ATTACHMENT I

PROPOSED TECHNICAL SPECIFICATION CHANGES

SINGLE RECIRCULATION LOOP OPERATION

POWER AUTHORITY OF THE STATE OF NEW YORK  
JAMES A. FITZPATRICK NUCLEAR POWER PLANT  
DOCKET NO. 50-333

Fig 3.5-8

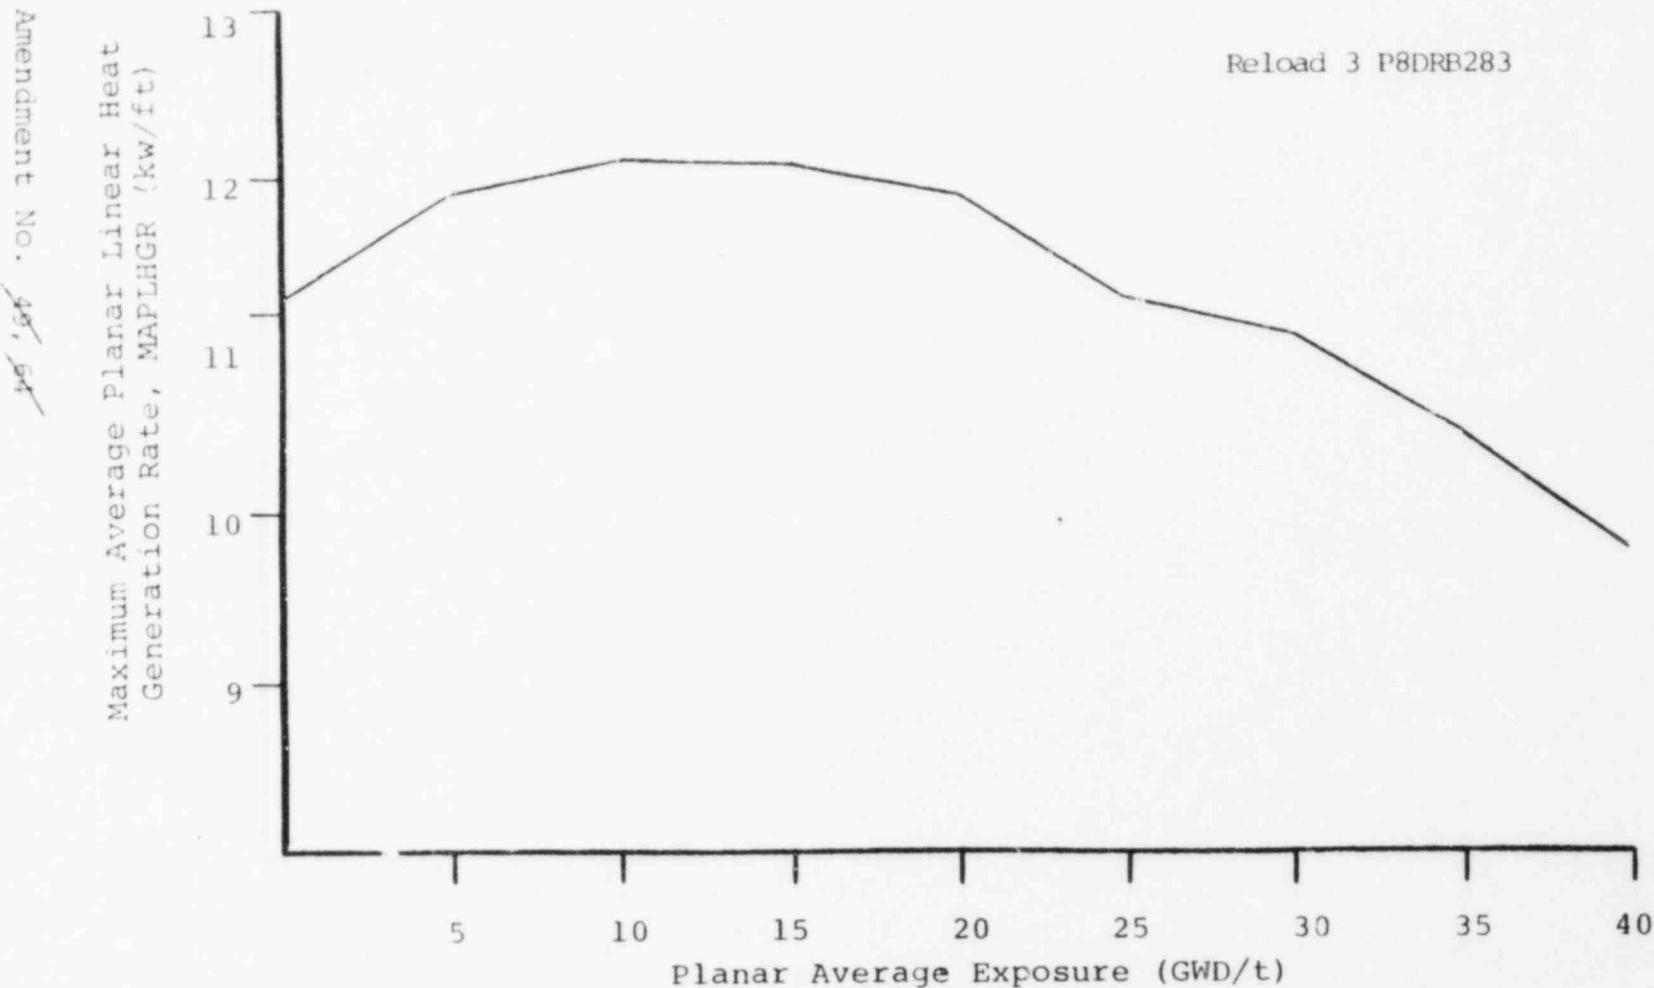
For single recirculation loop operation, these MAPLHGR values should be multiplied 0.84.

Figure 3.5-9

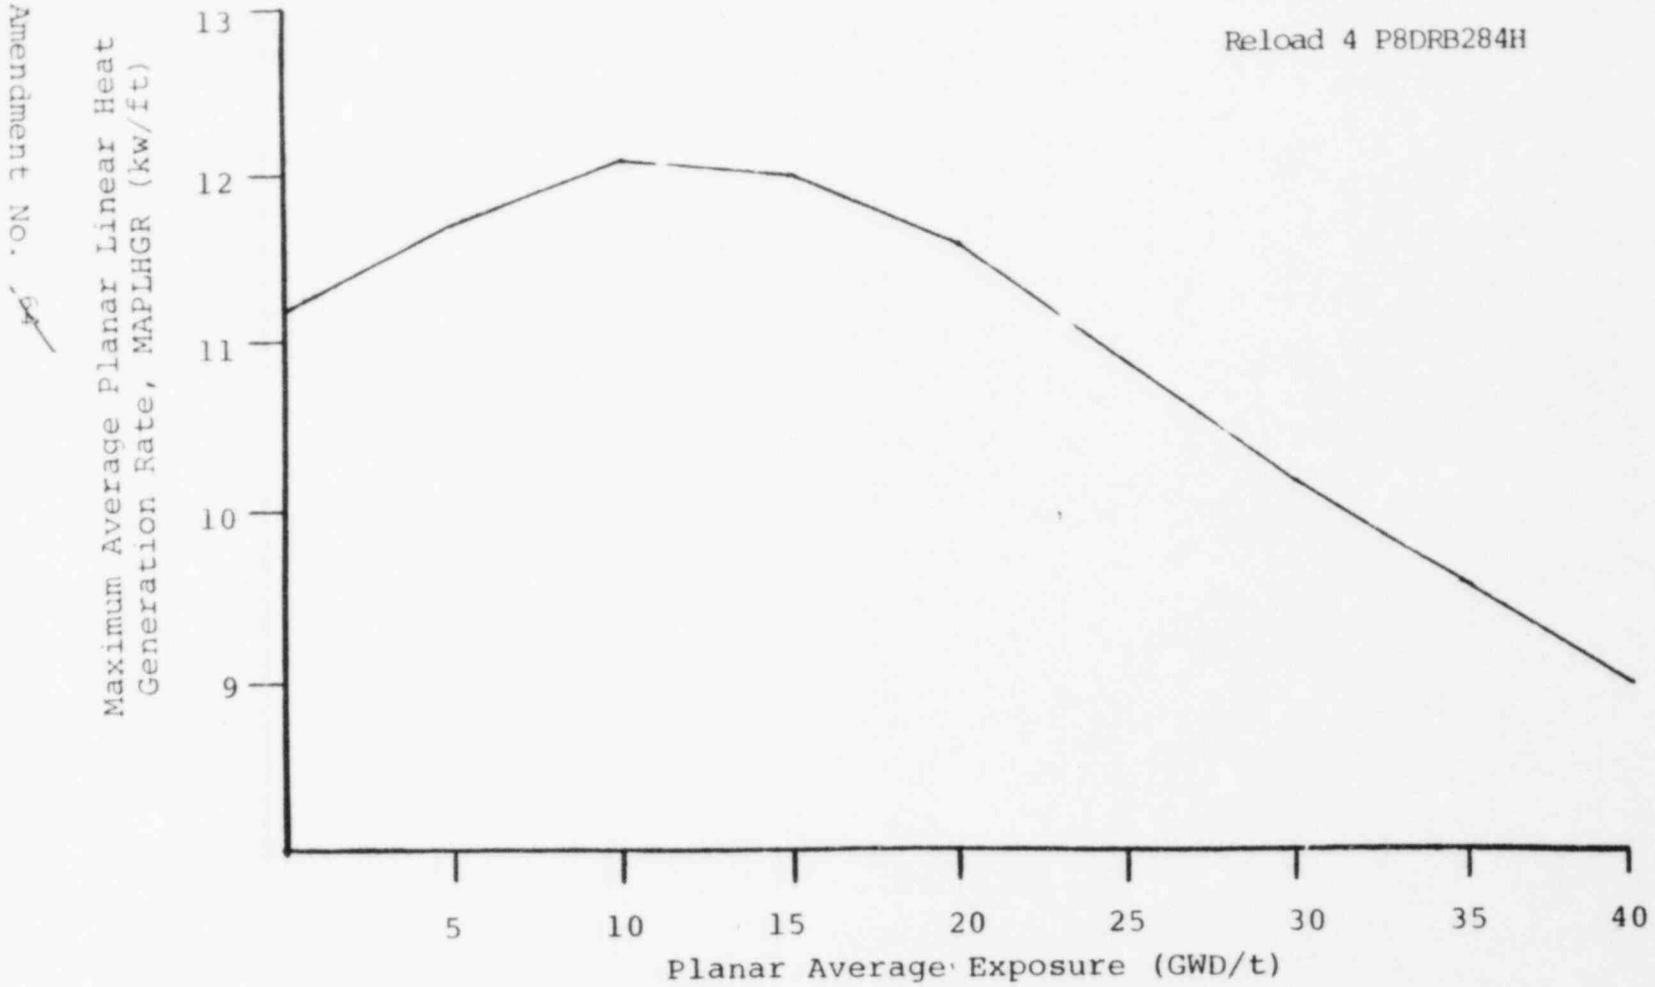
For single recirculation loop operation, these MAPLHGR values should be multiplied 0.84.

Figure 3.5-10

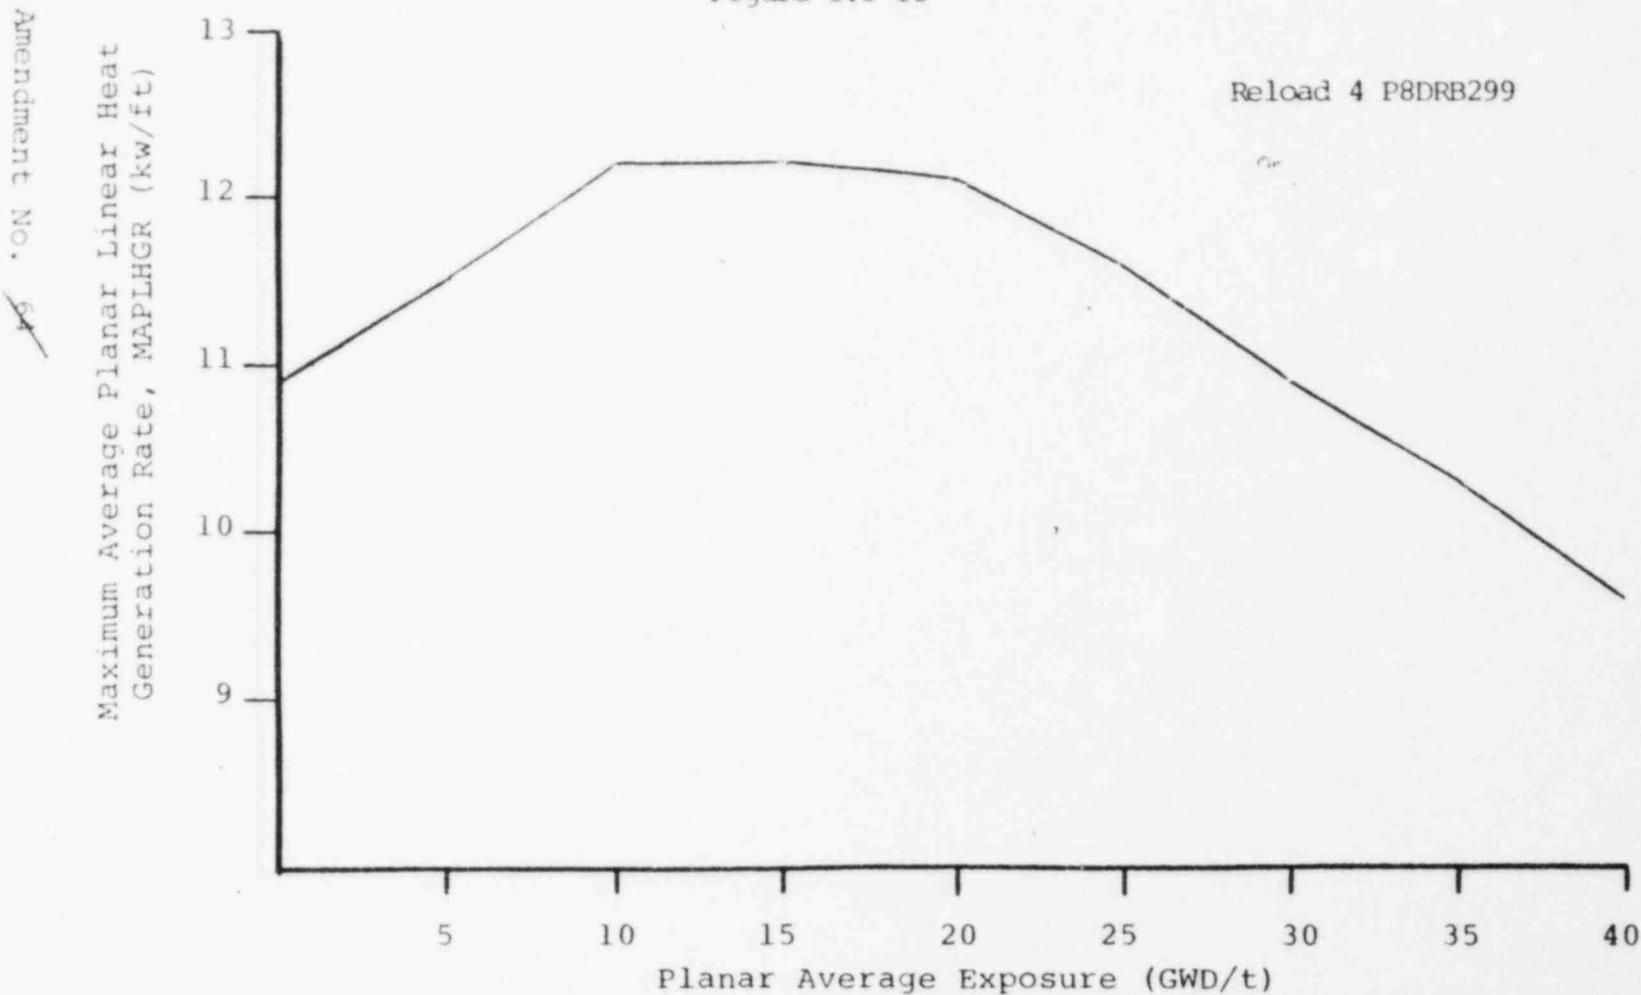
For single recirculation loop operation, these MAPLHGR values should be multiplied 0.84.
